RfR Tunnelling Questions for Independent Expert (Jan 2009)

**Prepared by the Independent Engineering Expert panel for Dublin Metro North
February 2009 (minor revisions March 31st 2009)**

i. Crossover formed from running tunnels

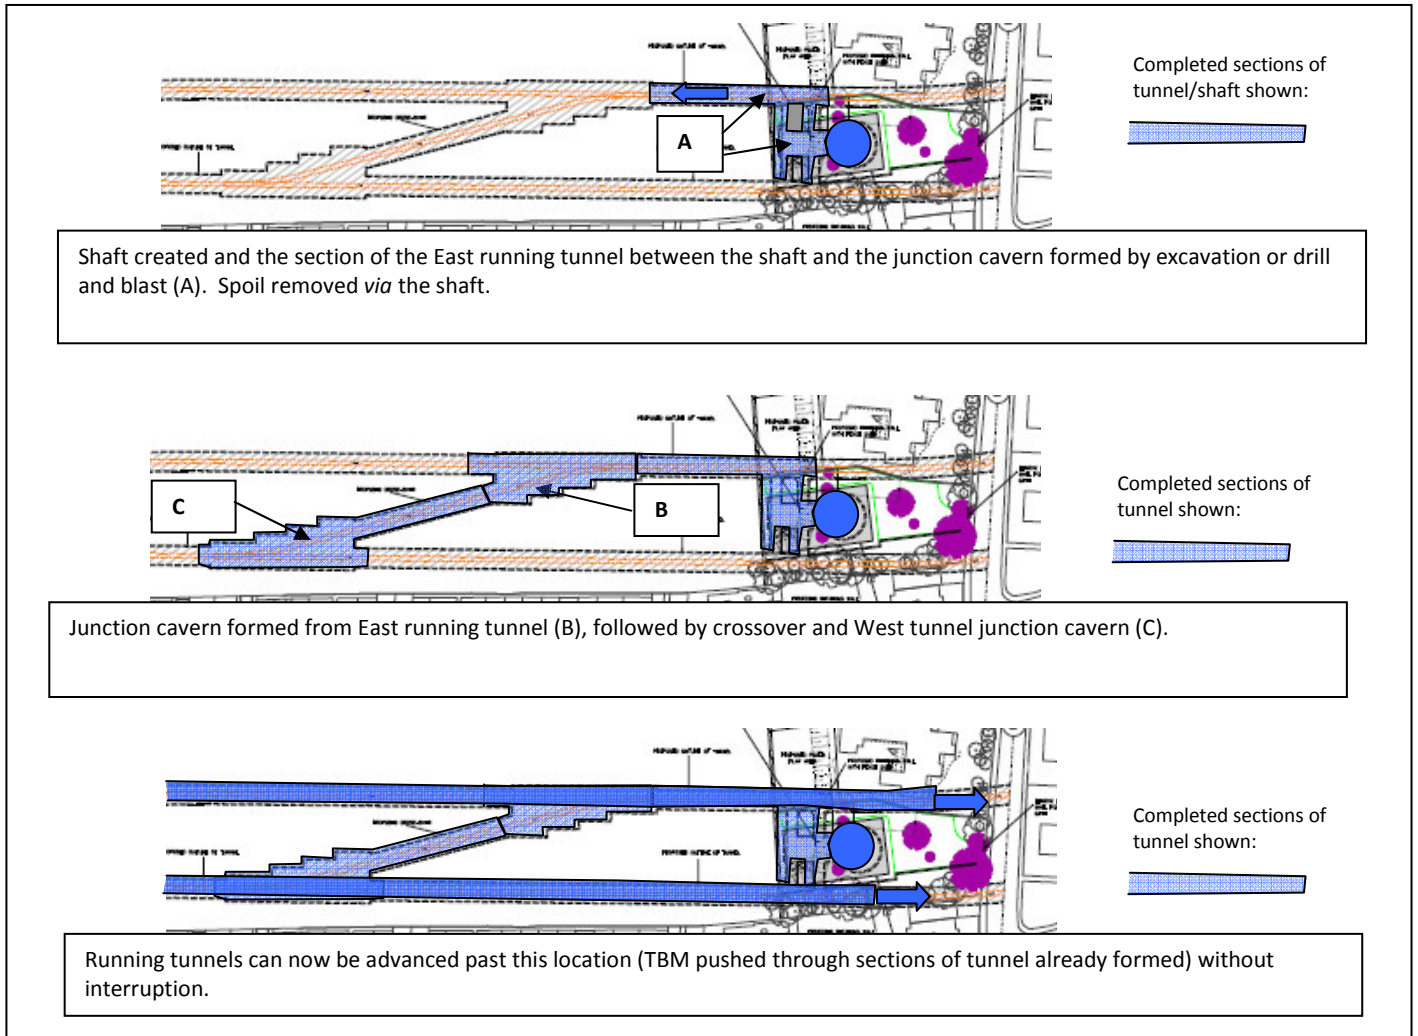
Both running tunnels (A1 and A2 above) advanced by TBM beyond the junction with the crossover tunnel. Behind each TBM is the transport and support infrastructure for the TBM (conveyor or railway for spoil out and materials in, electricity, hydraulics etc)

Running tunnel linings need to be removed and then the tunnel at the junctions (B1 and B2) will be widened out. Whilst this is done, the TBM operation will be interrupted because it will not be possible to maintain the transport and support infrastructure past the junction works. The construction of each junction would disrupt the progress of the TBM in that tunnel whilst the work is completed (either the TBM would stop in the affected running tunnel for the duration of the works on the junction or there would be frequent interruptions to its progress). Spoil from the junction caverns would be removed via completed sections of running tunnels.

Once each junction cavern is complete, the TBM infrastructure can be re-established and boring of the running tunnels can resume without further interruption. The crossover itself (C) can be completed between the junction caverns whilst the TBM is operating (from one end or the other or in both directions alternately or simultaneously).

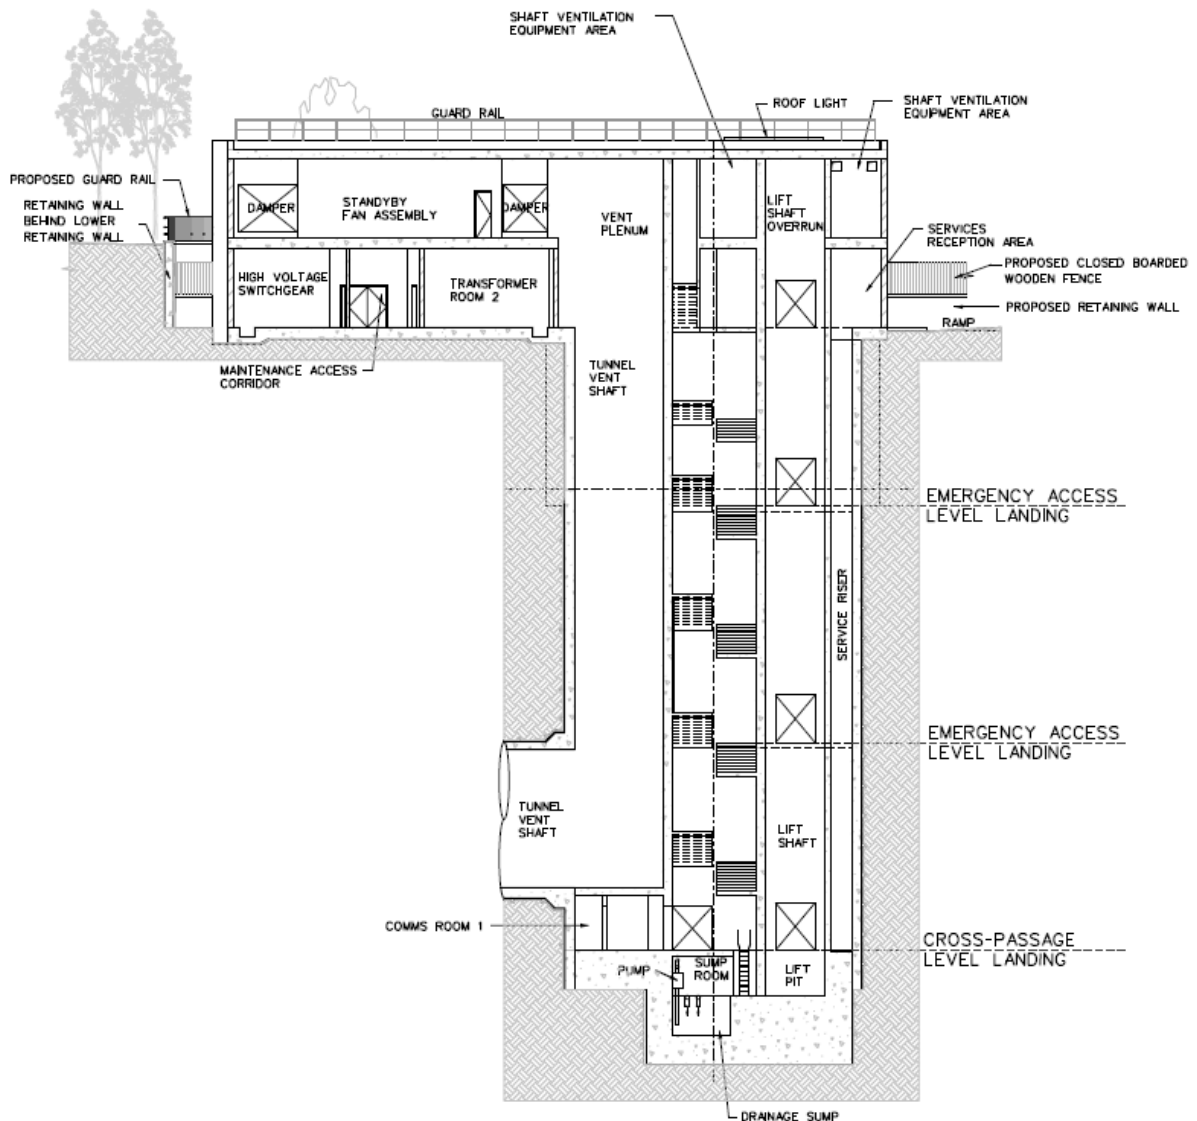
7. *Is the design of the ventilation shaft in relation to the positioning of the 2 tunnels significant?*

The alignment runs from Griffith Avenue to Drumcondra in bored tunnels. As the length of the bored section of tunnel between Griffith Avenue and Drumcondra stations exceeds 1km, an emergency access and ventilation shaft is required for fire safety and for operational reasons, approximately at the midpoint of the section^[EIS, V1, Ch5, p63 & Ch6, p78]. The positioning of this shaft in relation to the surface and the running tunnels is the most expeditious; it is approximately midway between the two stations and is between the two running tunnels. Its location in relation to the tunnels ensures that the underground route for emergency egress from either tunnel is as short as possible. Similarly, its proximity to the tunnels (by being between them) reduces to a minimum the length of additional tunnels that will be required for the purposes of ventilation. Its surface location is in the corner of a sports pitch. Whilst the site access is onto rather narrow residential streets, emergency vehicles and personnel would be able to gain access to it *via* St Patrick's College. This surface location would ensure that those evacuated from the tunnels in an emergency would emerge into an open space and not spill onto the streets.

A shaft offset from the tunnel line (*e.g.* to facilitate access for emergency vehicles from larger roads or to move the shaft building and ventilation fans further away from buildings) would require the construction of additional ventilation/draught relief tunnels, thereby increasing the cost of the project. It is probable that operational costs would also be higher due to a requirement for higher power ratings for ventilation fans (and there may be implications for meeting thresholds in relation to airborne noise levels).
